STATE SIGNIFICANT DEVELOPMENT ASSESSMENT REPORT:

*Site 53, No.2 Figtree Drive,
Sydney Olympic Park*

(SSD 7662)

Environmental Assessment Report
Section 89H of the *Environmental Planning and
Assessment Act 1979*

Figure 14: Revised Figtree Drive elevations (Source: RtS)

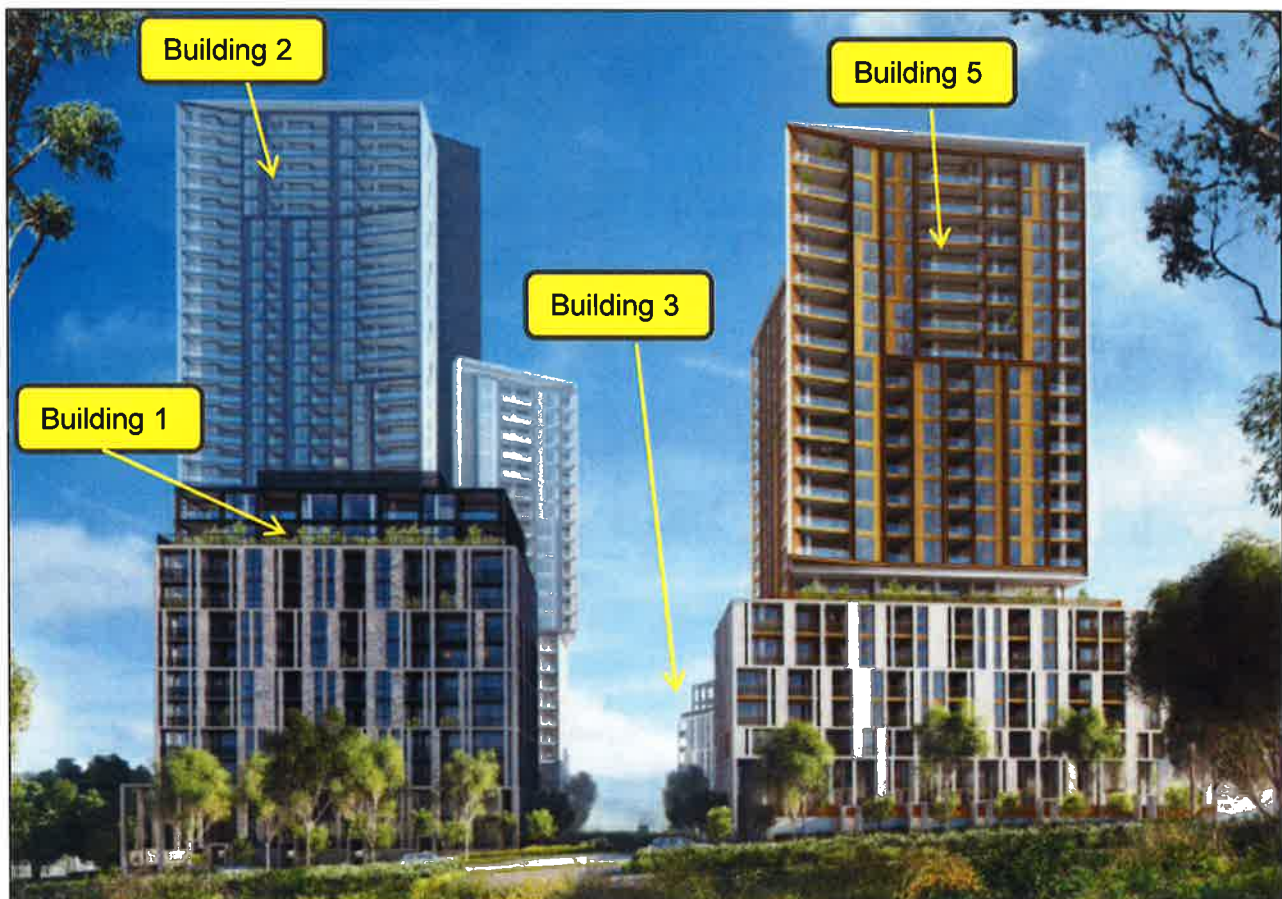
GMU has reviewed the RtS and supports the podium levels for Buildings 3 and 5 whilst recommending the height of the recesses proposed for Buildings 1 and 2 should be consistent with those at Buildings 3 and 5 by creating a podium and recess effect between Levels 8 to 10.

GMU's advice has also noted that while the proposal does not provide the required tower setbacks, the provision of a recess is considered acceptable given the prominent corner location of Building 2 and the site. However, GMU also advised the recess at Level 11 does not appear proportionate to the overall mass of the building and does not have sufficient height, at one storey, to be effective.

Figure 17: Floorplates for Buildings 2 and 5 (Source: RtS)

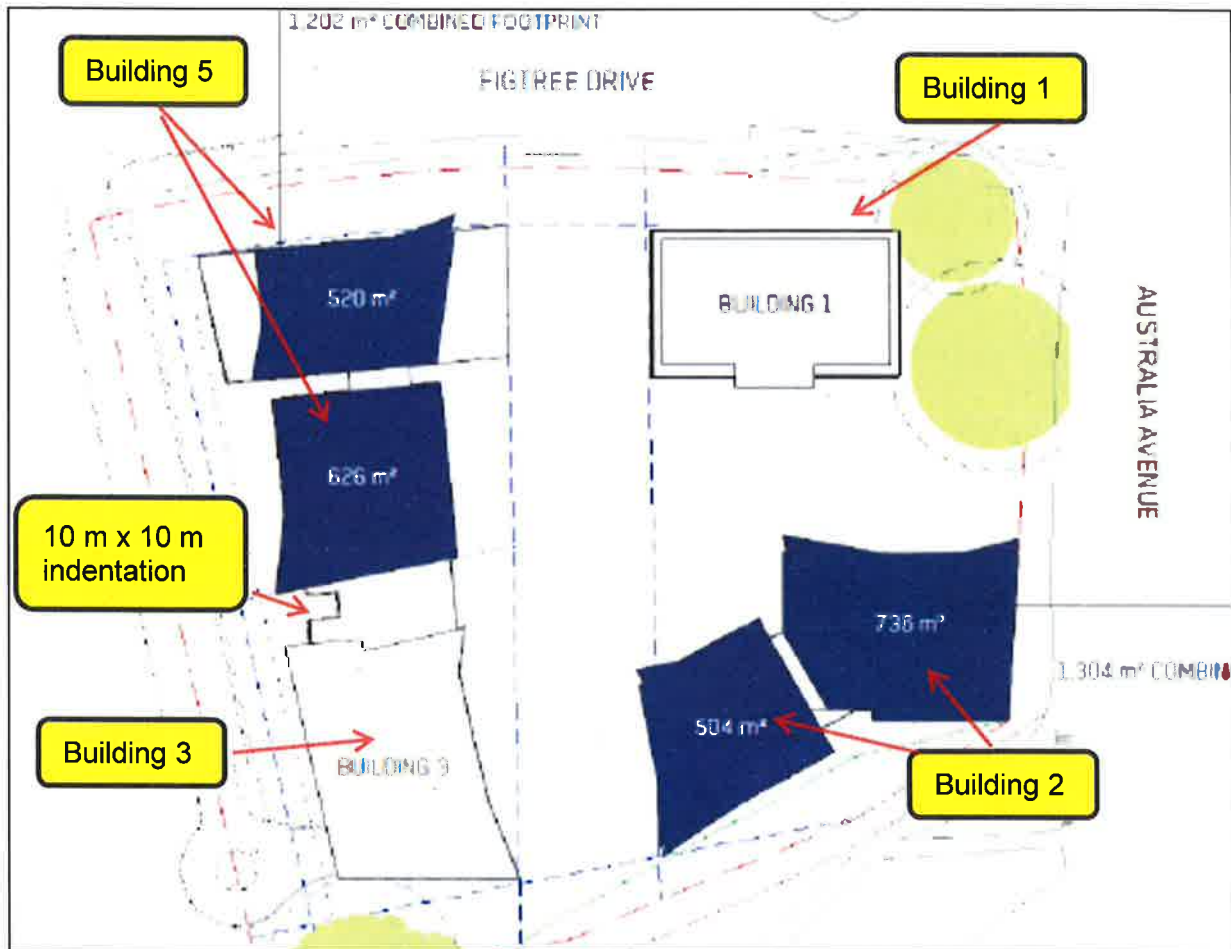
- while Buildings 2 and 5 provide the largest floorplates, greater than 800 m², they are designed with central cores and residential apartments located in two wings (**Figure 17**) off the core consistent with the design provisions of the Draft Master Plan where the maximum numerical standard of 600 m² is exceeded

- the connecting element between Buildings 3 and 5 has been recessed to provide an indent of 10 m x 10 m which breaks up the mass of the buildings when viewed from New Street (**Figures 15 and 17**)
- the buildings are highly articulated with setbacks, recesses and distinct material palettes
- by providing two separate wings for Buildings 2 and 5, the towers are able to be read as separate building elements regardless of their total floorplates.

The Department notes that the building designs provide a highly modulated built form which will align with the original intent of the floorplate controls in providing an articulated building form.

Figure 18: Shadows cast by the proposal and the existing Australia Towers at 9 am, Midday, 3 pm mid-winter (Source: Applicant's EIS).

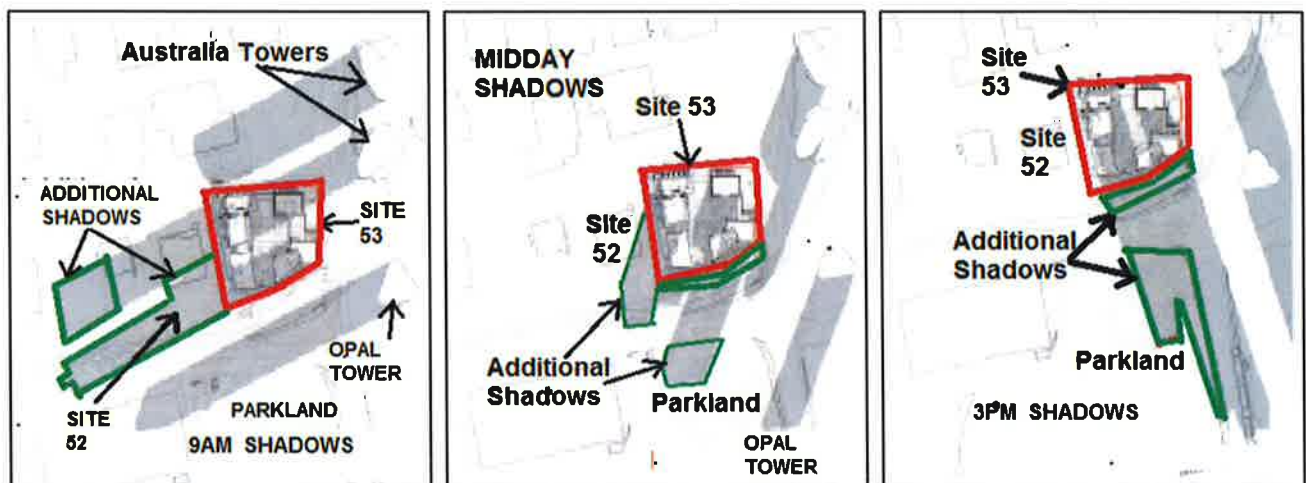
The subject development has potential to overshadow neighbouring lands, including Sites 51 and 52 to the west and Linear Park and Bicentennial Marker Park to the south (**Figure 18**).

Site 52 to the west would be affected during the early morning to the southern portion of the site through to midday for the western portion of the site. Site 51 which is to the west of Site 52 would also be affected during early morning periods (9 -11 am) although it would not be affected after 11 am. The proposal would cast a shadow to a portion of Linear Park and Bicentennial Marker Park from 10 am in mid-winter, although the 20 m view corridor would provide solar access to Linear Park from midday until 2 pm.

The Department notes that overshadowing impacts will still achieve a minimum of three hours solar access in mid-winter to Sites 51 and 52 directly to the west and to Linear Park and the Bicentennial Marker Park directly to the south.

Figure 20: Southern boundary of the site and Linear Park interface (Source: RtS)

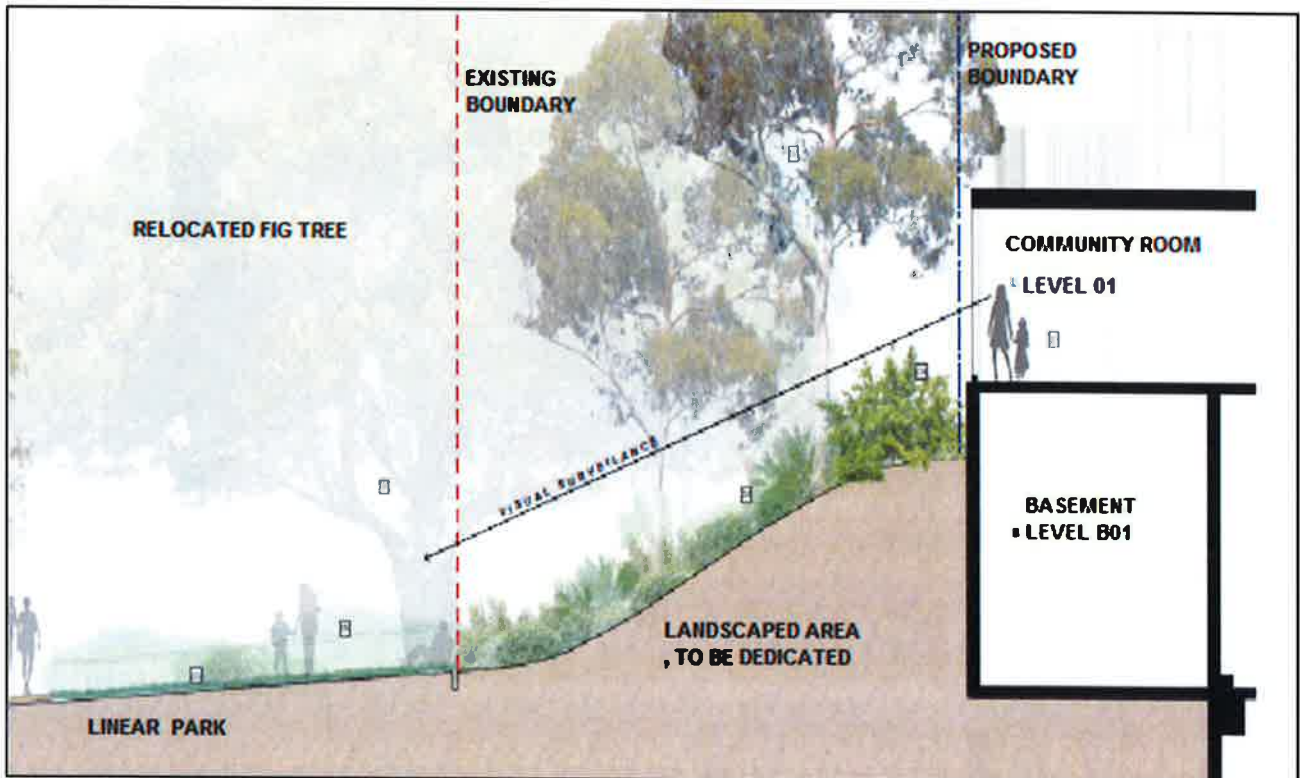
The landscape design of the interface between Building 3 and Linear Park includes plantings that would provide appropriate screening of the basement car park which sits approximately 1 m above ground level. This is due to the 6.25 m level difference between Fig Tree Drive and Linear Park. The interface between Building 3 and Linear Park will also include plantings along its Linear Park interface. While the proposal sets aside 908.5 m² of its entire southern frontage to be integrated into Linear Park, this will be subject to SOPA's future final design resolution and does not form part of the application (**Figures 20 and 21**).

The Applicant has advised the streetscape has been designed in accordance with SOPA's guidelines. In its review of the streetscape design, the DRP noted the quality and amenity and the public domain around Site 53 should be addressed by SOPA. SOPA in its response to the RtS has requested a Public Domain Interface Plan be prepared.

The Department accepts the area outside of the property boundary is the responsibility of SOPA and while the current design takes into account works outside the site, there is a need to seamlessly integrate the streetscape works within the site boundary with those outside the site. The Department

agrees that a Public Domain Integration Plan be prepared and a condition has been recommended in this regard.
